# Access Compliance Report

## Public Rights-of-Way

Intersection ID: 10037292	Main Street: SARDIS_RD	Cross Street: N/A	Location: NW
ADA ID: E4C5CC44B1C1	Ramp Type: MedianPerp	Initial Pass/Fail: Fail	Overall Compliance: No
Severity Score: 58.75			
Codes/Mitigation Info/Possible Solution		Field Measurements/Component Compliance

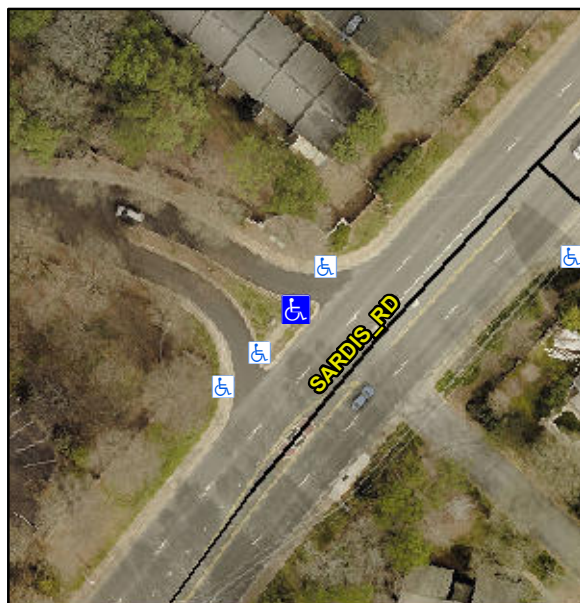
**Not Found, R304.5.1, R304.2.2, R304.5.3**

Compliance	Description	Data	Compliance	Description	Data
N/A	Ramp Length (in)	68.0	No	Ramp Slope (%)	17.3
No	Ramp Width (in)	46.0	No	Ramp XSlope (%)	9.0
N/A	Flare Type LT	N/A	N/A	Flare Type RT	N/A
N/A	Flare Slope LT (%)	N/A	N/A	Flare Slope RT (%)	N/A
N/A	Flare Traversable LT?	N/A	N/A	Flare Traversable RT?	N/A
N/A	Landing Length (in)	N/A	N/A	DWS Provided?	N/A
N/A	Landing Width (in)	N/A	N/A	DWS Contrast?	N/A
N/A	Landing Slope (%)	N/A	N/A	DWS Length (in)	N/A
N/A	Landing X Slope (%)	N/A	N/A	DWS Full Width?	N/A
N/A	Landing Curb? (Y/N)	N/A	N/A	DWS Offset (in)	N/A
N/A	Shared Landing?	N/A			
N/A	Gutter Ponding?	N/A	N/A	Gutter Slope (%)	N/A
N/A	Gutter Lip Ht (in)	N/A	N/A	Gutter X Slope (%)	N/A
N/A	Painted X Walk1?	No	N/A	Painted X Walk2?	N/A
	X Walk 1 Direction	To NE		X Walk 2 Direction	N/A
N/A	X Walk 1 Width (in)	N/A	N/A	X Walk 2 Width (in)	N/A
	X Walk 1 Slope (%)	2.7		X Walk 2 Slope (%)	N/A
	X Walk 1 X Slope (%)	7.6		X Walk 2 X Slope (%)	N/A

**Remove & Replace Entire Ramp.**
